CITY COMMISSION

Regular Meeting **February 12, 2026** **6:30 PM**

D. Recommendation to approve **SITE PLAN** for 1211 Winter Garden Vineland Road (Resurrection Catholic Church), subject to conditions – **Planning Director Carson**

Subject: 1211 Winter Garden Vineland Road (Resurrection Catholic Church Renovations)
Site Plan Approval
PARCEL ID# 12-22-27-6496-29-010

PROJECT NO. 23-110
SCALE 1"=40'
DATE MARCH 31, 2025
SHEET NO. C-9
SHEET 9 OF 20

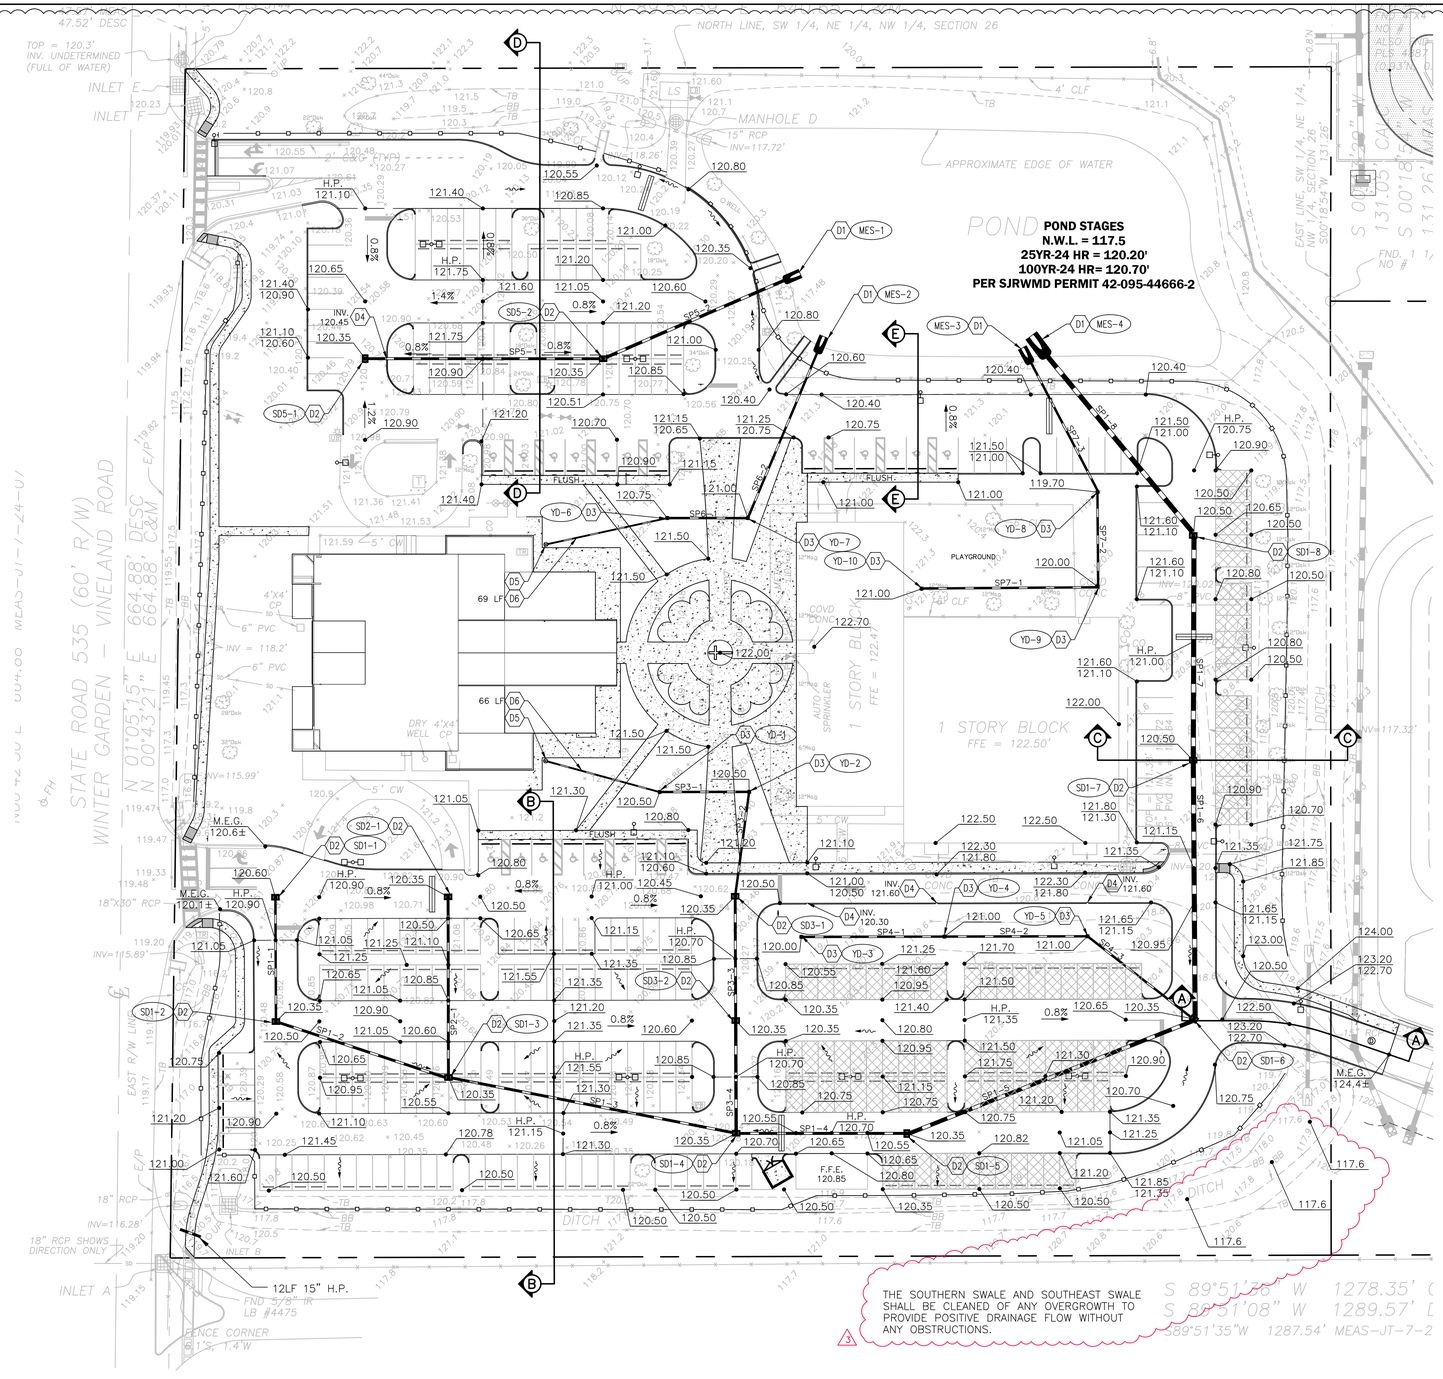
9. Sheet C-9 – Paving, Grading & Drainage Plan:
    a. **Per the 6/18/25 DRC meeting, this phase is to address the existing drainage problem at the south & southwest area of the property: the existing ditch needs to be cleaned out to provide positive drainage. Callouts for this work have been included and will be checked during construction for compliance.**
